## Draft Homebush Movement and Place Connectivity and Streetscape Upgrade Feedback

Thank you for the opportunity to provide feedback on the Draft Homebush Movement and Place Connectivity and Streetscape Upgrade (*The Plan*).<sup>[1]</sup> These comments have been prepared on behalf of CAMWEST, a Bicycle NSW affiliated Bicycle User Group (BUG) with a focus on advocating for and encouraging cycling in Western Sydney.

*Marked-up image from first map in concept design pack.*

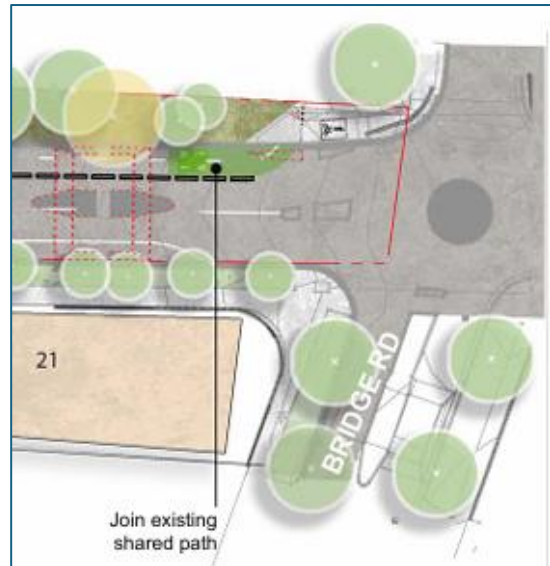
- **No crossing of The Crescent at Bates St shown.**

The Crescent can be moderately busy, and it sometimes takes a little while to make a safe right turn from Bates St into The Crescent. It would be good to include a combined pedestrian and cyclist crossing here. Riders travelling west either along The Crescent or through Airey Park will also potentially need to cross the road under this configuration, resulting in more riders crossing than at present. Realistically though, I think a lot of riders travelling west from Bridge St along The Crescent will join the roadway down the hill at Bridge St to avoid the two crossings.

*From first map in concept design pack.*

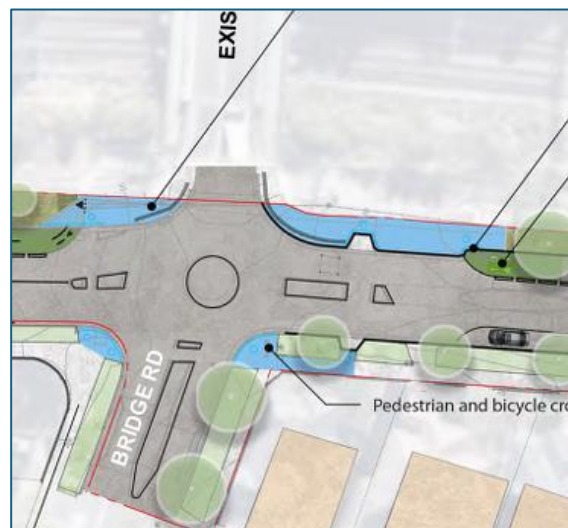
- **Virtually non-existent shared path at the corner of The Crescent and Bridge Rd.**

The markings on the image to the right may be incorrect, as you couldn't realistically call the area indicated as an existing shared path. It is a pad of widened concrete leading to a narrow footpath (Around 1.2m at one point, widening to around 1.6m while crossing the Bridge St railway bridge), and has no shared path markings.

*One 'pad' of wider concrete. Is this considered a 'shared path'?*

Looking at Loftus Crescent from Subway Lane just outside the railway underpass.

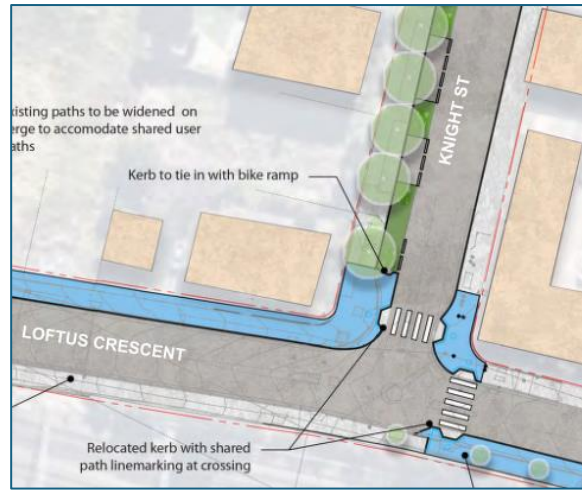
- **Subway Lane underpass**

I'm assuming the footpath needs to be built-out into the current roadway on The Crescent just west of Subway Lane, as currently the footpath is quite narrow.

Would at least one tree require removal on the corner of Subway Lane and Loftus Crescent to get the increased path width?

*From 'Sheet 4' in concept design pack*

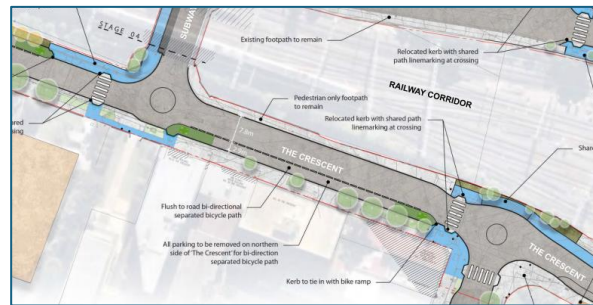
- **Changing sides of The Crescent between Subway Lane and Rochester St**

Again riders need to cross The Crescent twice within a short distance. I can see that there aren't any obvious alternatives to doing this, but I can also see that it may annoy some riders. Again, please provide an option for those confident on-road riders heading east to join The Crescent roadway for this short section.

*Pathway between The Crescent and Beresford Rd*

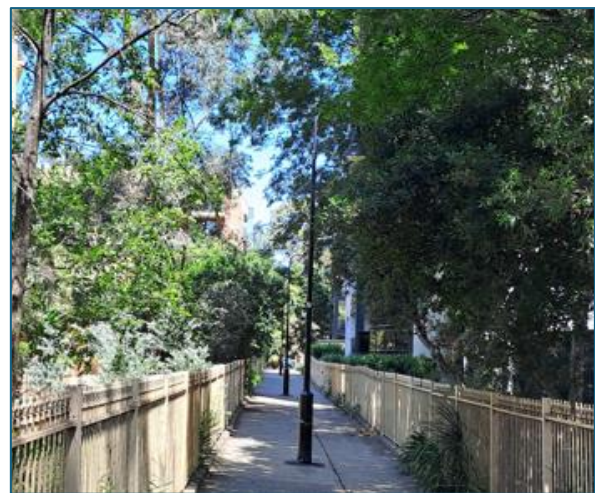
- **Pathway between The Crescent and Beresford Rd:**

Are there any plans to move the existing light poles from the centre of the pathway? If not, placing reflective tape around them may make them more obvious so riders don't collide with them.

*Mark-up of 'Sheet 9'*

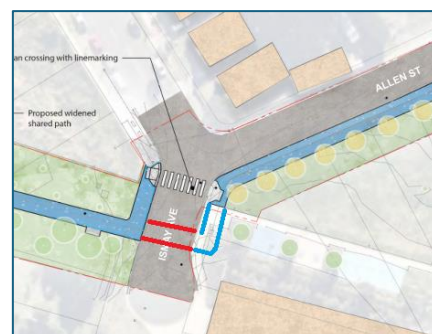
- **Ismay Ave crossing**

If feasible, it would seem better to me to move the crossing down on Ismay Ave to make it in line with the existing shared path on the western side. This removes one of the 90 degree turns on the path.

From 'Sheet 9' in concept design pack

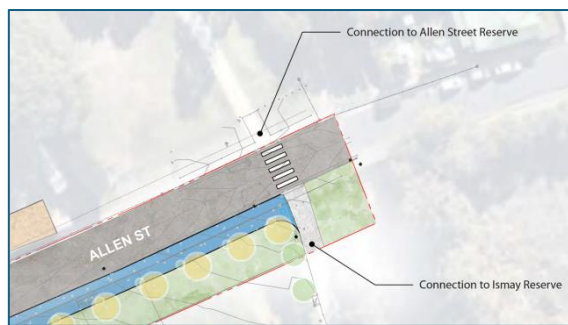
- **Allen St crossing**

It's encouraging to see that a combined pedestrian/cyclist crossing is being proposed at the current Allen St crossing on the Powell Ck path. I hope this crossing will negate the need for one of the sets of 'Cyclist Dismount' signs currently on this section of path.
